February 09, 2023

**URGENT FIELD SAFETY NOTICE
MEDICAL DEVICE CORRECTION**

Datascope Cardiosave Hybrid and Rescue Intra-Aortic Balloon Pumps (IABP)

Figure 2: As pictured in **Cardiosave Hybrid and/or Rescue Operating Instructions**

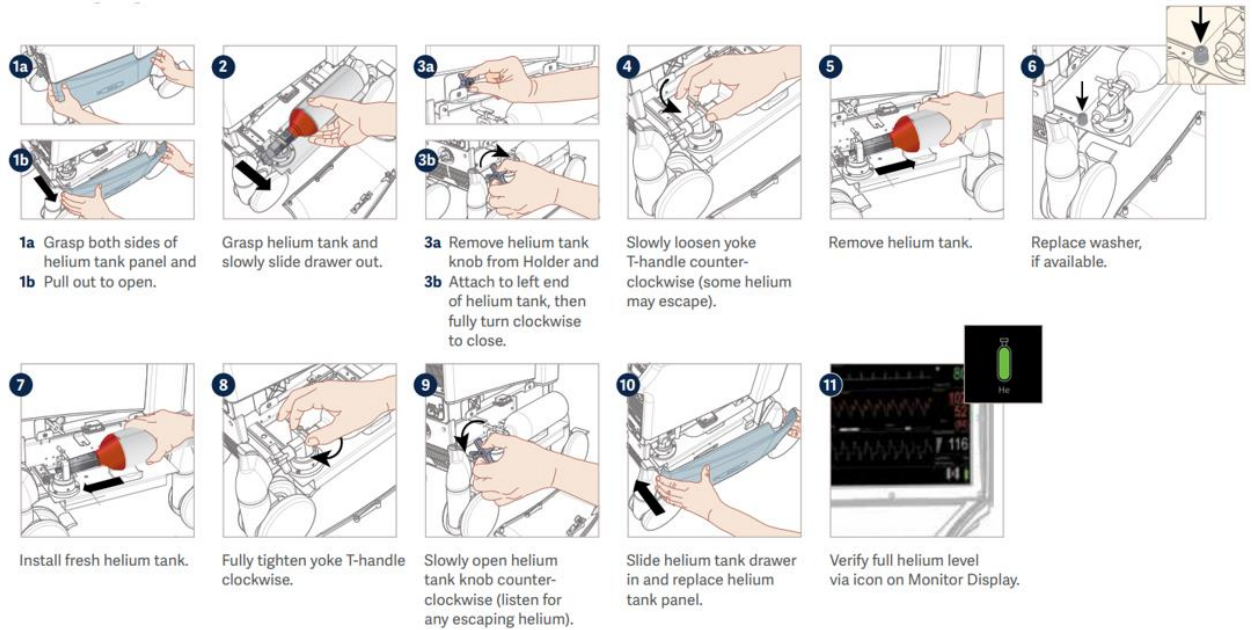
Issue 3: Leak in the High Pressure Helium Regulator

There have been reported failures of the high pressure helium regulator which may cause a helium leak in the Cardiosave Hospital Cart. The high pressure helium regulator is located in the Cardiosave Hospital Cart and regulates the helium pressure of the external helium supply. In instance of helium regulator failure, a Pump Console's internal reservoir of helium will not be replenished when docked into an impacted Hospital Cart. This may result in an insufficient amount of helium within the internal reservoir. Please refer to images below for reference.

Should a Cardiosave's helium supply be depleted due to an impaired helium pressure regulator, therapy may be interrupted. As with any therapy interruption, the degree of subsequent hemodynamic stability is related to the patient's overall clinical condition, those critically ill are more vulnerable to clinical decline. The risk of therapy interruption from a depleted helium supply is mitigated by the advanced notice provided to the User (a minimum of approximately 24 hours). The Pump Console's internal helium reservoir may be restored by utilizing another hospital cart or a helium refilling station. Should helium replacement not be feasible or another IABP console not available for use, alternative means of providing hemodynamic support (vasopressors, inotropes or alternate therapies) may be initiated by a healthcare provider as a temporizing measure.

1. During Installation and Replacement of Helium Tank per the Cardiosave Operating Instructions, please ensure care is taken not to damage the helium tank or the helium tank yoke while inserting and/or removing the helium tank.
2. Please follow the instructions for use when changing the helium tank.

3. If user observes any visual damage on High Pressure Regulator, please contact your Datascope/Getinge service representative.

Datascope/Getinge is currently investigating this issue to determine root cause and will notify customers if additional action is to be taken to correct the issue.

Figure 3: Drawings as pictured in **Cardiosave Hybrid and/or Rescue Operating Instructions**, along with a final picture of the O-ring as it appears on the unit.

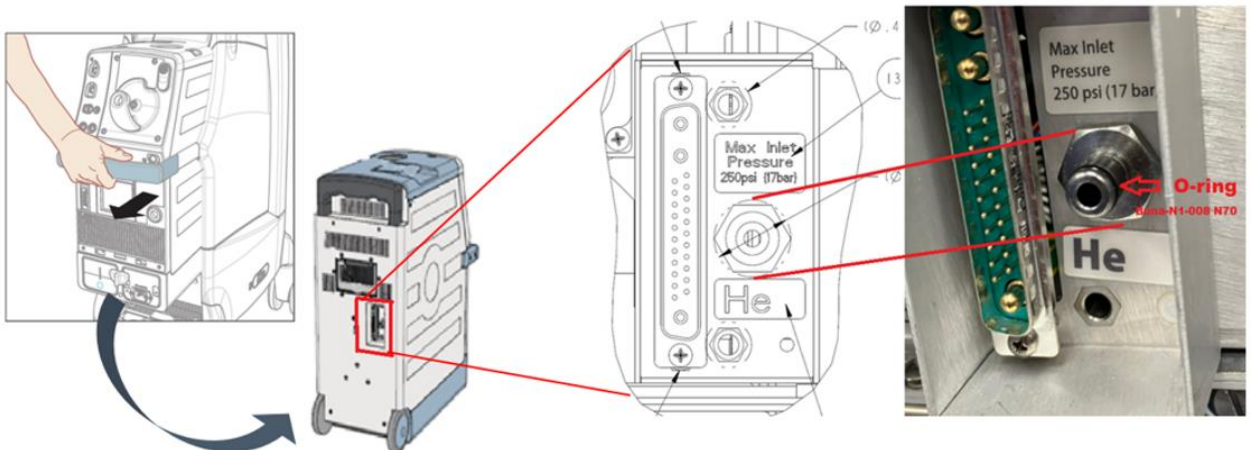
Issue 4: Helium Leak at the Pump Console Quick Disconnect Fitting

There have been reports of damaged, worn, or torn O-rings on the Cardiosave Pump Console quick disconnect fitting resulting in helium tank leaks. The quick disconnect fitting is the point of connection that permits the refilling of the Pump Console's internal helium reservoir when the Pump Console is docked in the Hospital Cart. Please refer to images below for reference.

Should a Cardiosave's helium supply be depleted due to an impaired quick disconnect, therapy may be interrupted. As with any therapy interruption, the degree of subsequent hemodynamic stability is related to the patient's overall clinical condition, those critically ill are more vulnerable to clinical decline. The risk of therapy interruption from a depleted helium supply is mitigated by the advanced notice provided to the User (a minimum of approximately 24 hours). The Pump Console's internal helium reservoir may be restored by utilizing another hospital cart or a helium refilling station. Should helium replacement not be feasible or another IABP console not available for use, alternative means of providing hemodynamic support (vasopressors, inotropes or alternate therapies) may be initiated by a healthcare provider as a temporizing measure.

1. If user observes any visual damage to the O-ring installed as part of the quick disconnect fitting, please contact your Datascope/Getinge service representative. If possible, remove the IABP from patient use until appropriate repairs can be made.

Datascope/Getinge is currently updating the annual Preventive Maintenance instruction to include replacement of the quick disconnect fitting O-ring.
